AGENDA
Regular Hybrid Meeting
Town of Granby
Inland Wetlands and Watercourses Commission
Wednesday, August 13, 2025, at 7:00 pm
Town Hall Meeting Room

MEETING MINUTES
Town of Granby
Inland Wetlands and Watercourses Commission
Wednesday, July 9, 2025, at 7:00 pm

SHEET 1 OF 1

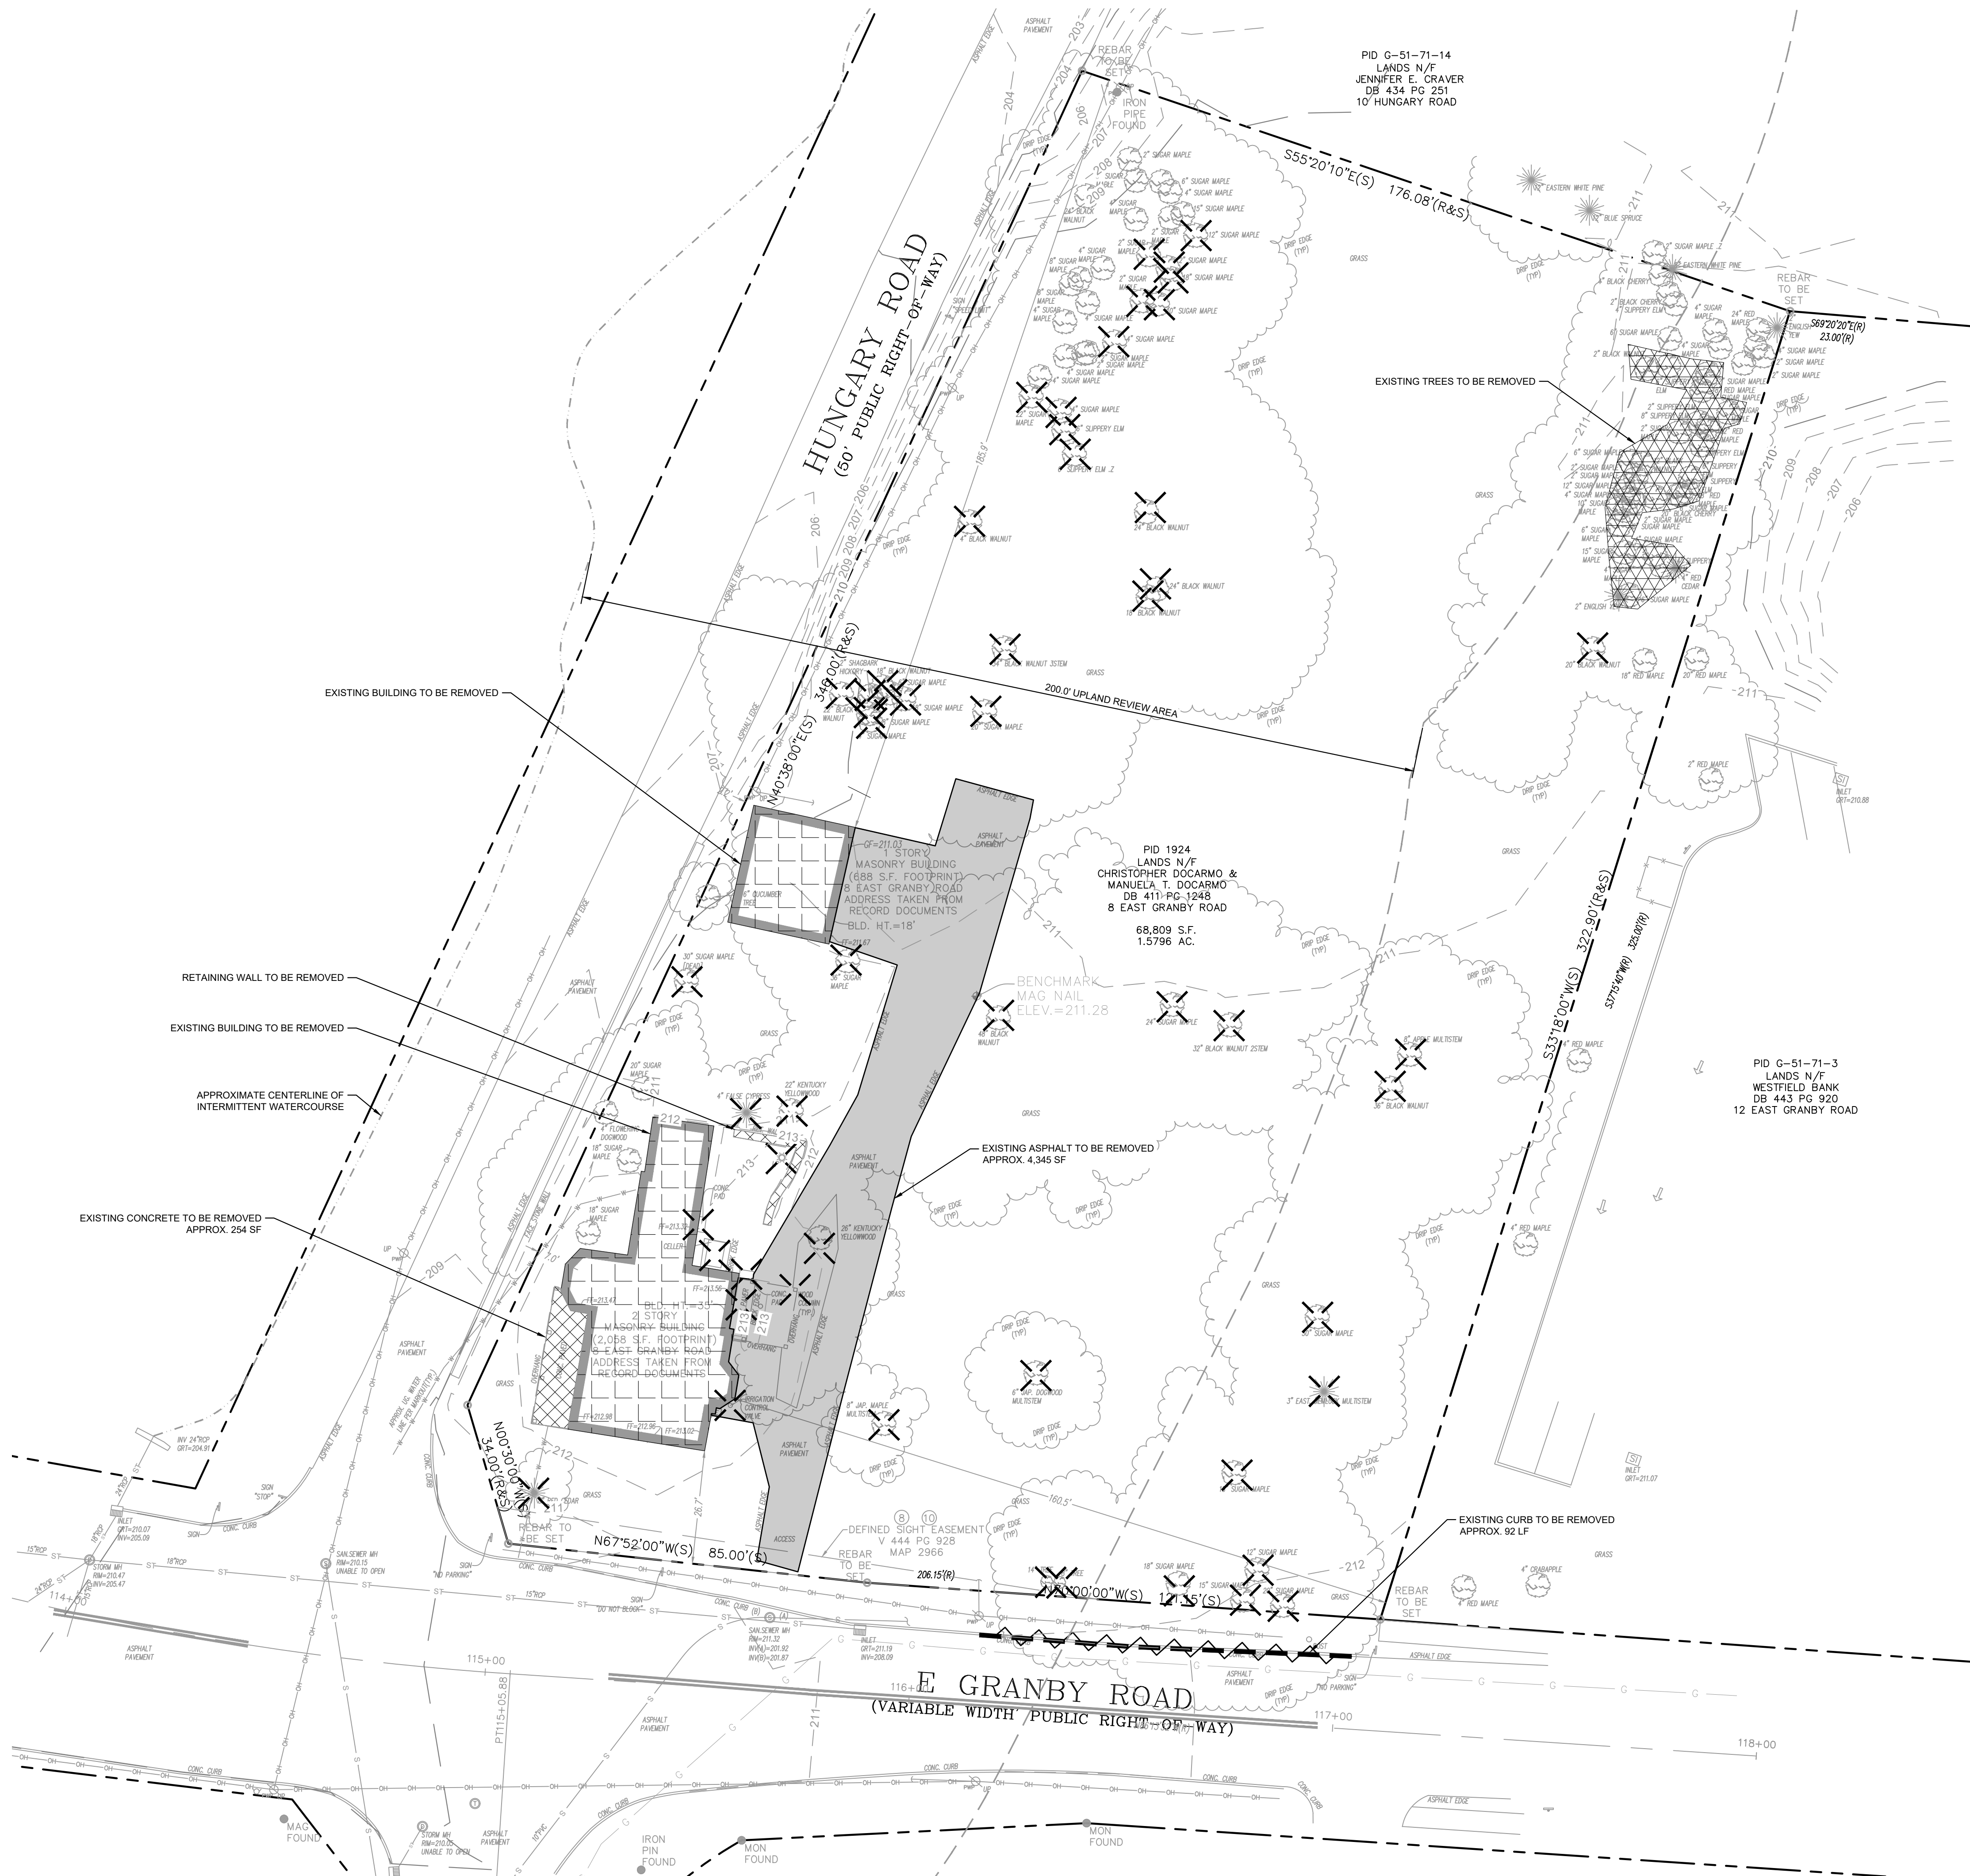
1. Show and label existing sidewalk.

Response: The existing sidewalk is shown, and a label has been added on the Survey Sheet.

SHEET NUMBER
C-3.0

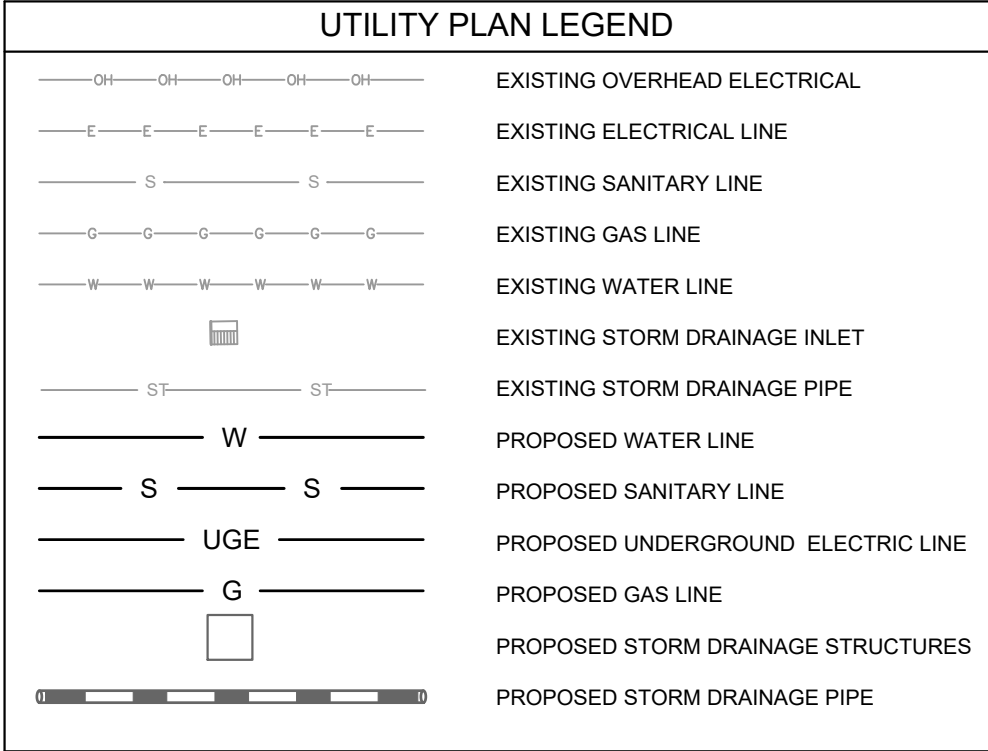
Sheet C-3.0

2. Show test hole information on this sheet.

3. Add the test hole pit data to the report and on sheet C-3.0. Test pits and soil data reporting to comply with the Connecticut Stormwater Quality Manual, March 30, 2024, Chapter 10, Test pits and Borings, pages 178 and 179.

Response: Sheet C-3.0 has been revised to include the test pit information (testing elevation and infiltration rate).

Response: Test pit data is included in the SWMP on page 14 and the full geotechnical report is provided in Appendix A.

Per the CT Stormwater Quality Manual, if the infiltration rate exceeds 8.3 in/hr, then 100% of the stormwater quality volume requirement must be treated using a different stormwater management practice before entering the infiltration basin. Therefore, the project stormwater management plan has been revised to include a bioretention basin before the

infiltration basin to treat the required water quality volume. The provided site plans and SWMP have been revised to include the bioretention location and details.
